AMENDED
NOTICE OF DECISION

DATE: **March 22, 2021**
PROJECT NAME: Mountain Meadows Administrative Subdivision
PROJECT LOCATION: 8818 Burnett Road SE, Yelm, WA
PARCEL NUMBERS: 21713310400, 21713310401, 21713310402
CASE NUMBER: 2020.0341.PR0011

ADMINISTRATIVE SUBDIVISION 2020. 0341.PR0011

AMENDED FINDINGS OF FACT, CONCLUSIONS OF LAW, AND DECISION

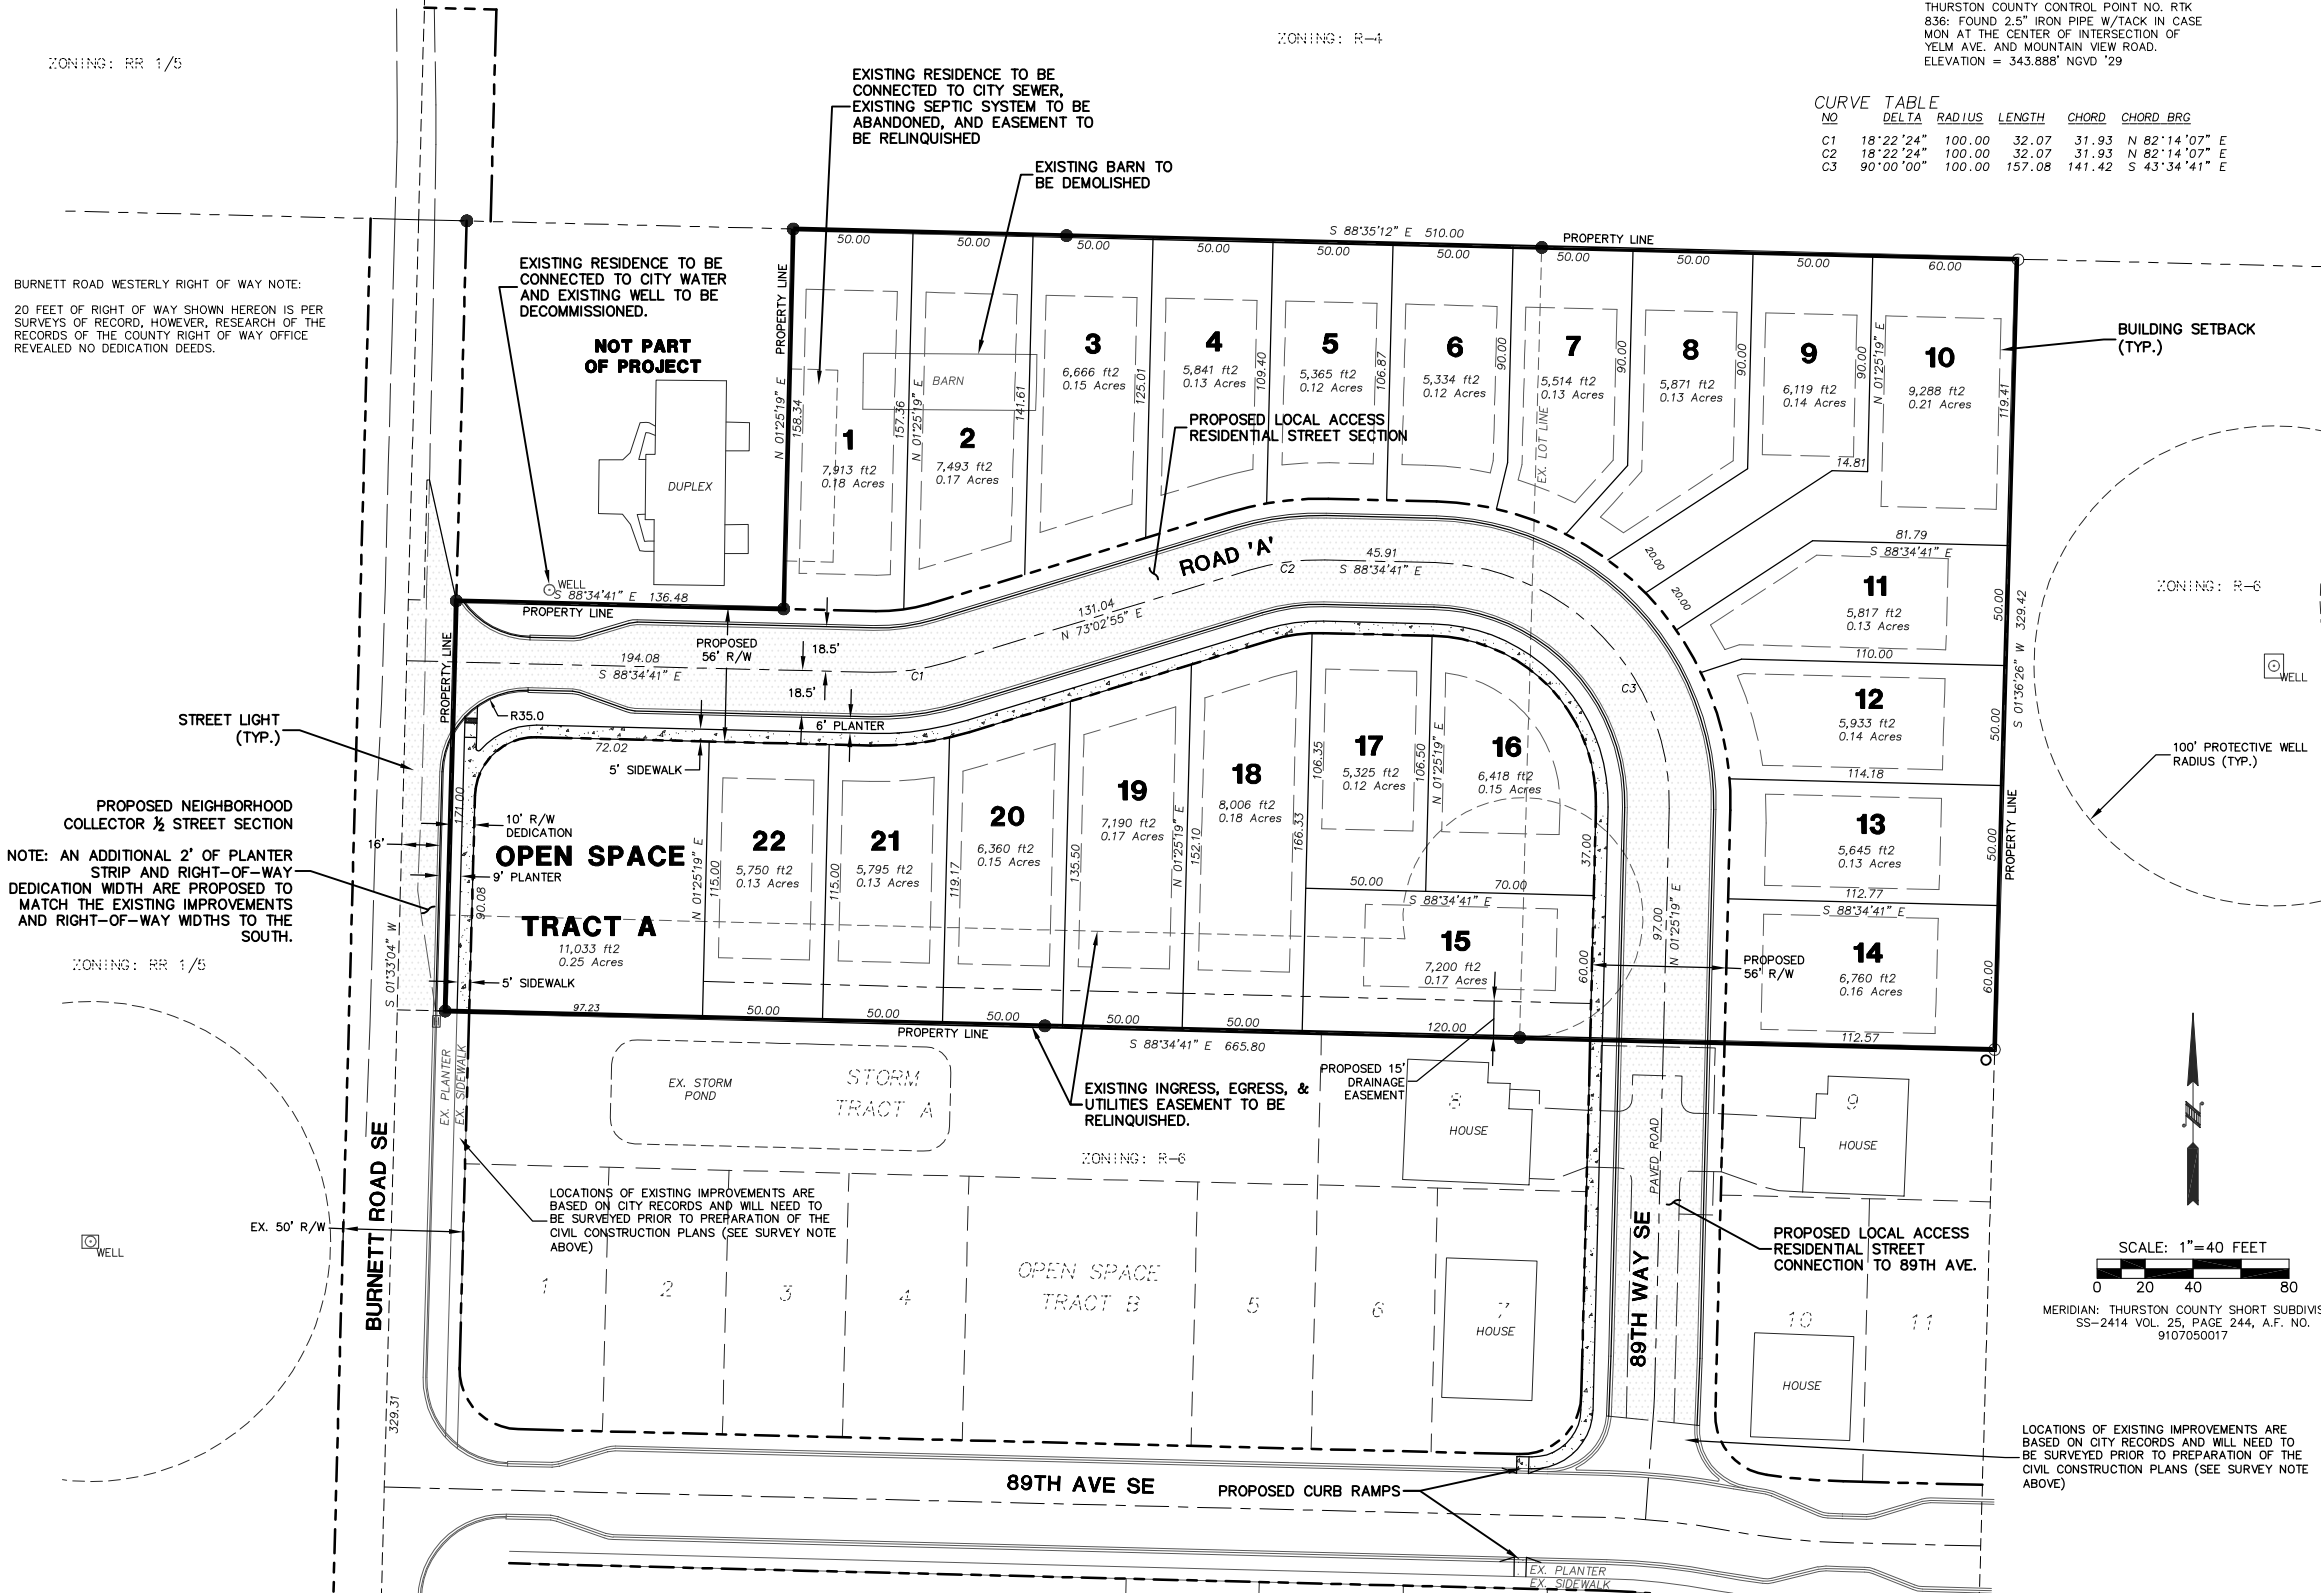
The preliminary plans show the underground stormwater tract as open space but does not show how the space will be improved to meet recreational open space standards.

The conceptual plan shows a utility easement for stormwater drainage along the southern property line, in location of required rear yard setbacks for lots 15 – 22.

The location of the storm drain line within the required rear yard setbacks poses several issues, including access for maintenance, probability of fencing, sheds and other structures constructed over the line, and possible planting of trees and shrubs over the line. This issue should be addressed within the CCR's for the development, as well as clearly marked and limitations described on the face of the subdivision map.

5. The detailed landscape plan shall include recreational improvements that meet the qualified uses for opens space such as active recreation or play equipment.

14. The CCR's and Final Subdivision Maps shall clearly show the stormdrain easements, and any restrictions to development on or over the easement.
15. Each dwelling unit within the subdivision shall connect to the City water system. The connection fee and meter fee will be established at the time of building permit issuance.
